L.I.F.E. Report

ENVIRONMENTAL AND HEALTH IMPACTS  
OF MIDWAY LANDFILL

An Assessment of Available Information and Procedures  
of the Closure Plan and Remedial Investigation Plan

October 20, 1986

FIGURE 3-1 - GAS SAMPLING PROBES AND EXTRACTION WELLS

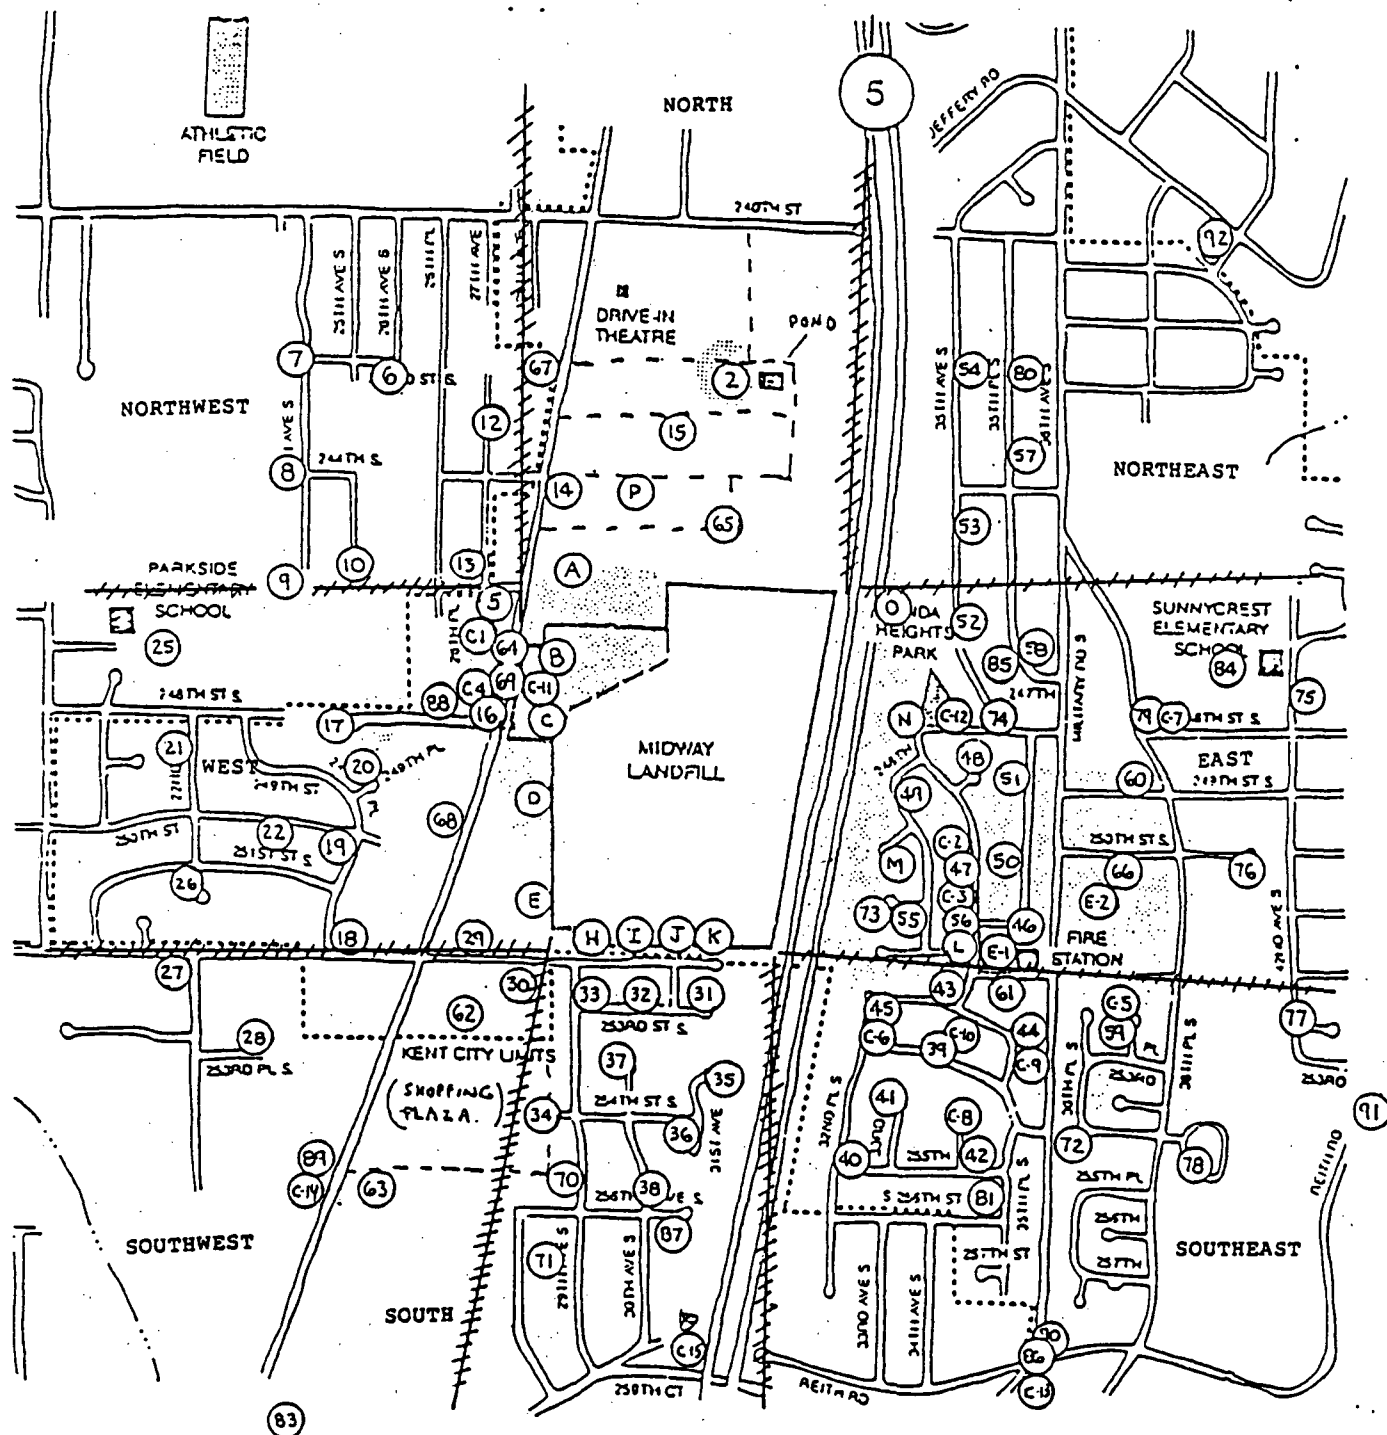
northwest and southwest because of the absence or scarcity of deep probes. Recent sampling in the south and southeast have established the existence of gas as far south as Reith Road; resulting in a new extraction well being established at the corner of Reith Rd. and Military Rd. Figure 3-1 shows areas where deep-lying methane has been found in addition to the shallow reservoir identified in the FEIS.

2. Wherever extraction wells have been established, they have successfully reduced the measured concentrations of methane within a few months time to levels below, or near, the "safe" level of 5%. Figure 3-2 is a typical extraction well methane trend.
3. Based on the data from probes L, M, N, and O, the migration of gas from the landfill toward the east was greatly reduced between September 1985 and February 1986, apparently as a result of the new perimeter gas control wells installed on the landfill site in late 1985. Some uncertainty is introduced into this conclusion, however, by the concurrent startup in early 1986 of extraction wells near the three probes with the highest concentrations.

FIGURE 4 - 2

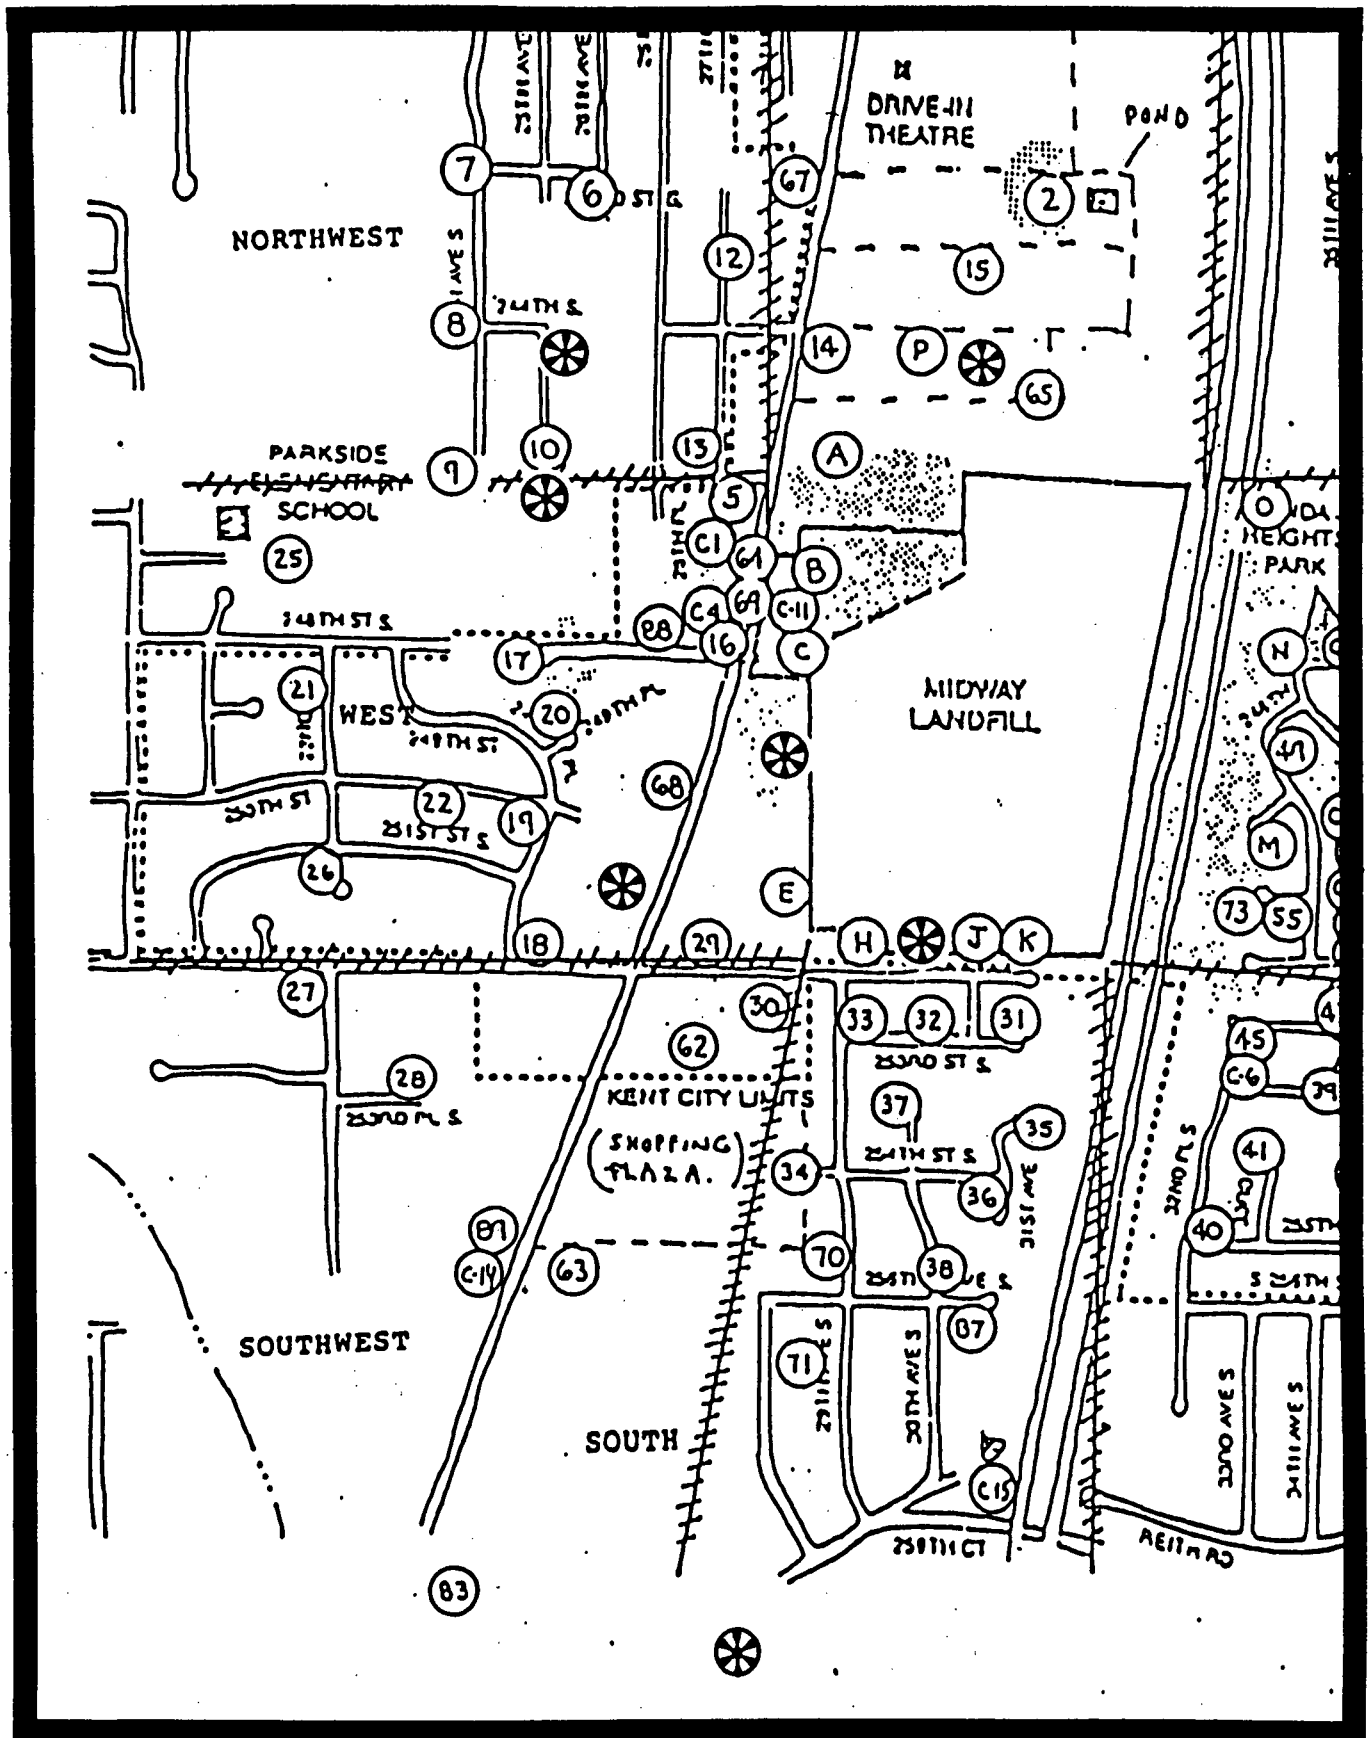
Limited analyses for volatile and semi-volatile priority pollutants also shows migration of these contaminants away from the landfill. Table 4-4 identifies the type of priority pollutant and lists those sites where the contaminants have been identified. As shown in Figure 4-2, these compounds have been found primarily on the landfill's west side.

# PROBABLE SCHEDULE

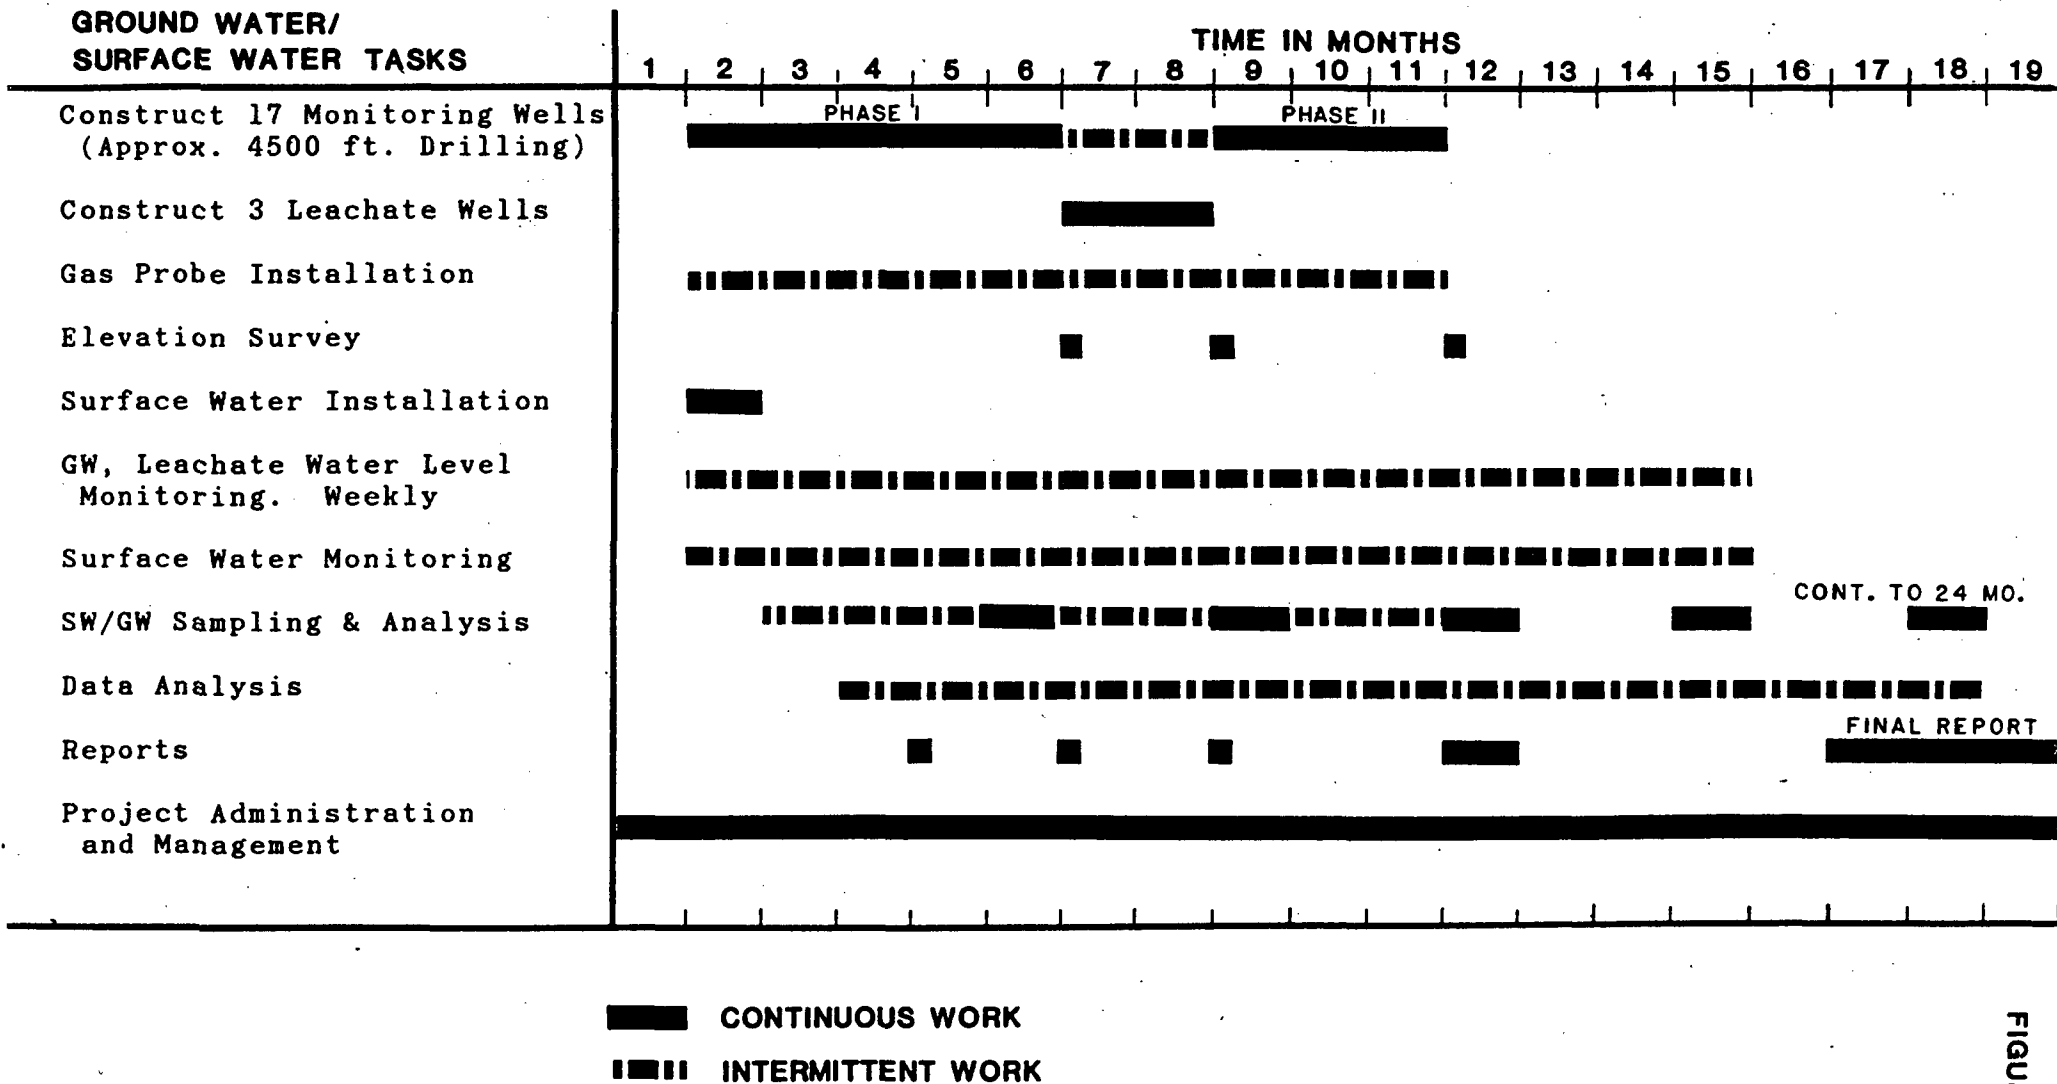
1. Figure 3-1, the RI Work Plan Schedule, shows completion of field activities at 34 weeks after notice to proceed (NTP) and completion of RI after 52 weeks. The L.I.F.E. team believes this schedule is not realistic and cannot be met.

7. Figure 4-3 illustrates a more likely schedule for the surface and ground water tasks described in the Work Plan.
8. Even if the monitoring well installation schedule shown in the Work Plan's Figure 3-1 could be met, monitoring and quarterly sampling could not be completed for at least 1 1/2 years after NTP.

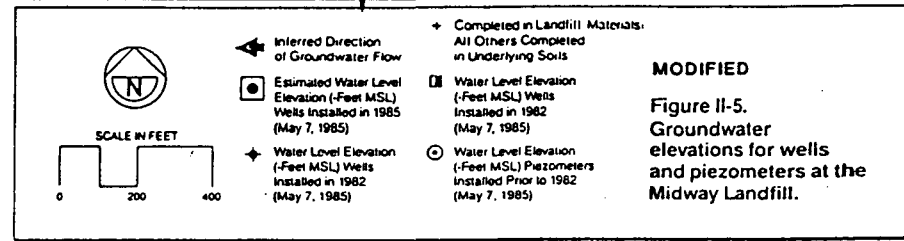
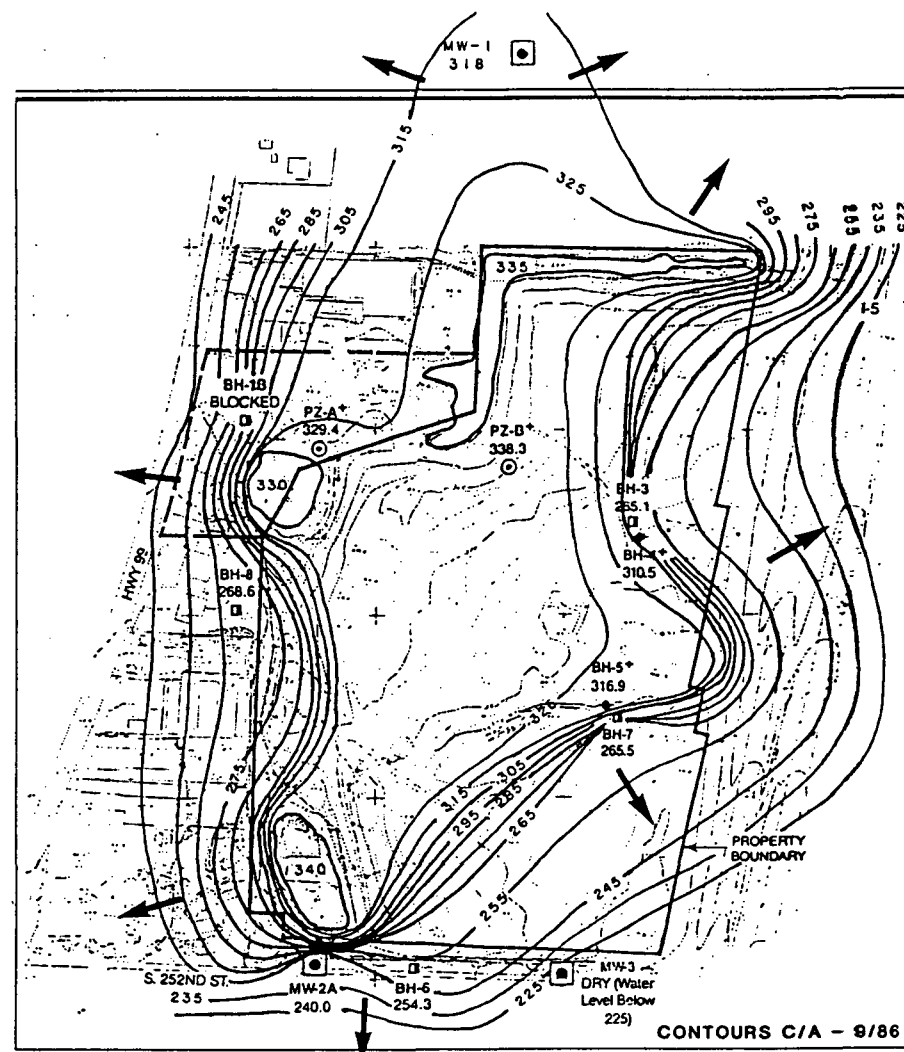
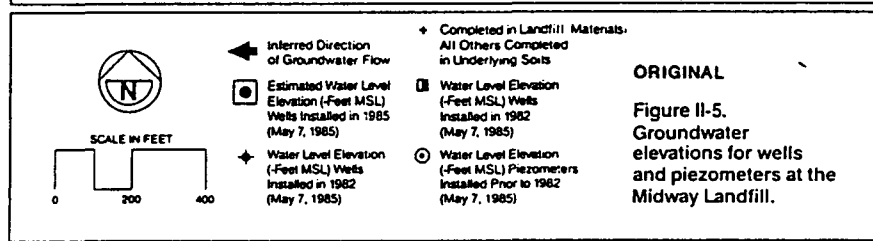
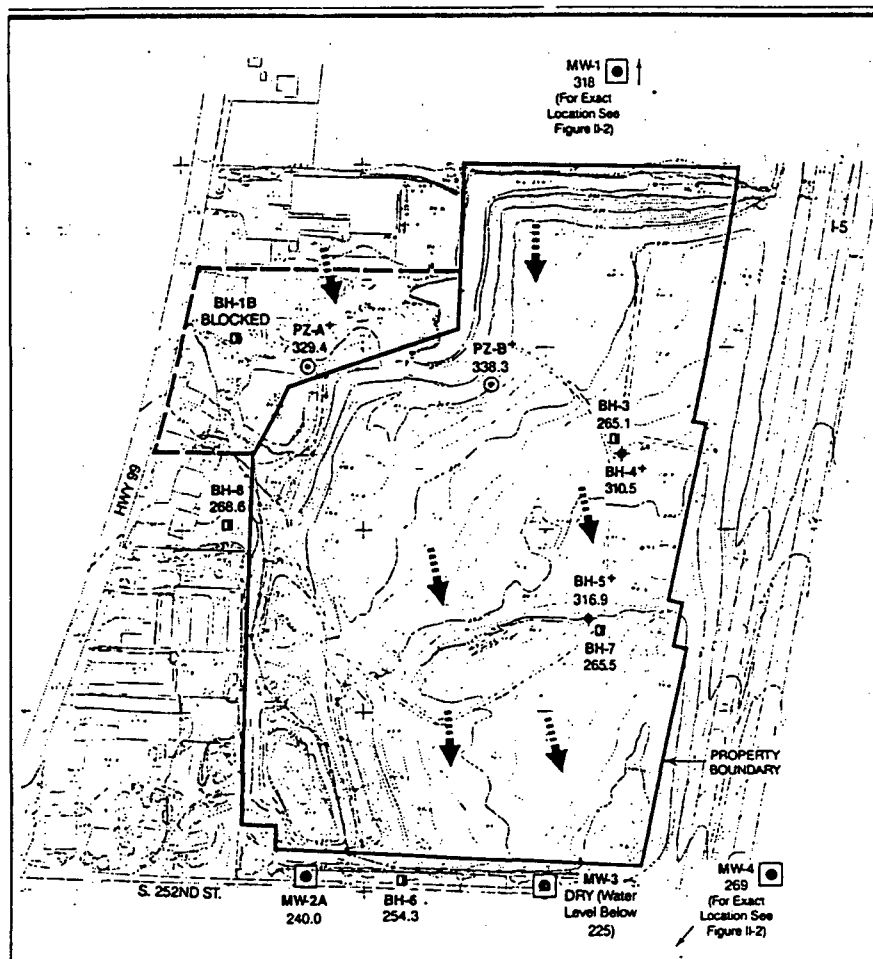
The attached Figure A compares the ground water flow direction described in the Final EIS and illustrated in Figure II-5 of the Draft EIS to a more reasonable representation prepared by our firm. As shown, careful interpretation of the same data used in Figure II-5 produces a radial flow pattern.

Water quality conclusions using analyses of water from wells located immediately north of the landfill are not valid. For example, the Final EIS (page II-8) suggests that background specific conductance is 245 umhos/cm, based on analysis of water from Monitoring Well 1 located "up gradient of the landfill." However, readings from other wells in the area indicate that background specific conductance probably does not exceed 150 umhos/cm. Our analysis (Figure A) shows MW-1 lying in the path of landfill leachate.

Recommendation: Ignore the findings of prior ground water work at Midway. Sample existing and new ground water monitoring wells on a quarterly basis for at least one year. Augment the State's MFS analytical requirements to reflect hazardous wastes and contaminants known to be present in Midway refuse and leachate. Establish realistic background water quality values. To evaluate the performance of the leachate management plan, use practical evaluation rather than proposed statistical methods which mask seasonal and other natural water quality variations.
